# Service Bulletin

Category K	Applicable Model/s 1988-90 626/MX-6 incl. Turbo	Subject EC-AT SLIPPAGE IN FORWARD GEARS	Bulletin No. 005/90 Issued 5/14/90 Revised
---------------	---	--	--

### SPOOL VALVE REPLACEMENT PROCEDURE

LINE PRESSURE

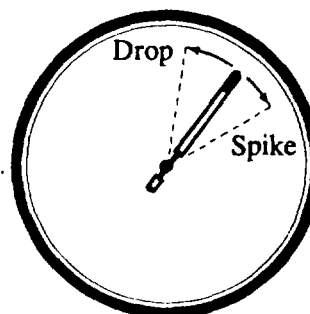
3. Perform the following tests while the engine speed is kept at 2,000 rpm in "Park."
  - A. Pull the throttle cable to the end of its travel (full throttle) and read the line pressure. Line pressure should be higher than 8.0 kg/cm<sup>2</sup> (115 psi).

- B. Next, quickly and smoothly pull the throttle cable out to one-half way of its travel (half throttle) and hold. Check for line pressure spike (maximum) and drop (minimum) readings using a line pressure gauge.

- A good oil pump should show a smooth increase of pressure and level off at a stable pressure.
    - If the spool valve of the oil pump is stuck, it may cause a pressure spike and variation in pressure before leveling off, or it may show little/no increase in pressure. (Refer to the illustrations.)

4. If a problem is found in Step 3, replace the oil pump spool valve according to the Replacement Procedure.
5. Recheck the line pressure according to Step 2 and perform the road test to confirm that the problem is fixed.

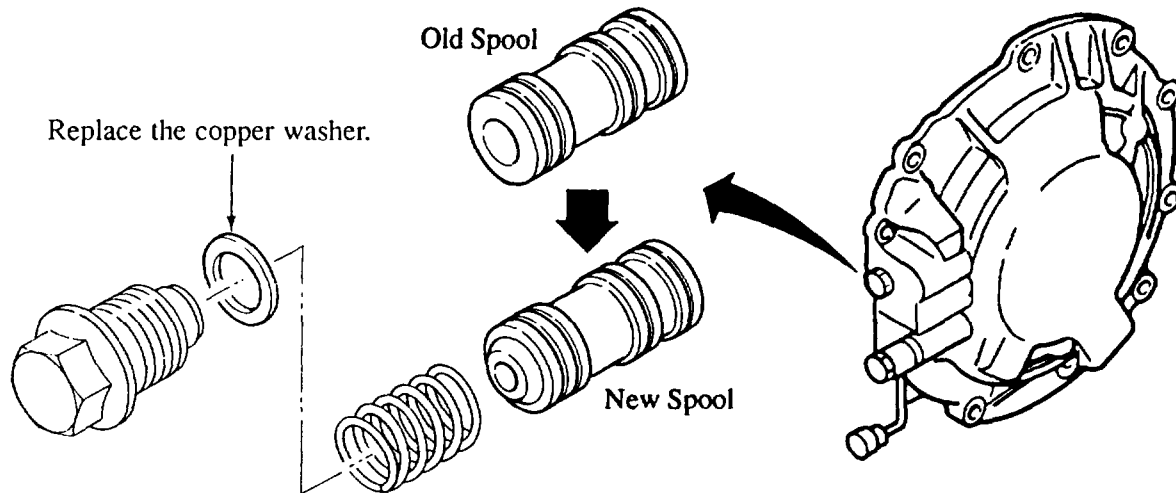
1. Lift up the vehicle on a hoist.
2. Remove the spool valve plug using 19mm swivel socket and a 6in extension.

3. Remove the spring and spool valve with a small pencil magnet.
4. Insert the new spool valve into the oil pump with the partially closed end pointing outward.
5. Insert the spring until it becomes flush with the oil pump housing.
6. Replace the copper washer on the spool valve plug and reinstall the plug onto the oil pump housing. Tighten the plug by the specified torque.

Specified Torque: 2.4–3.6 m·kg (17–25 ft·lbs)
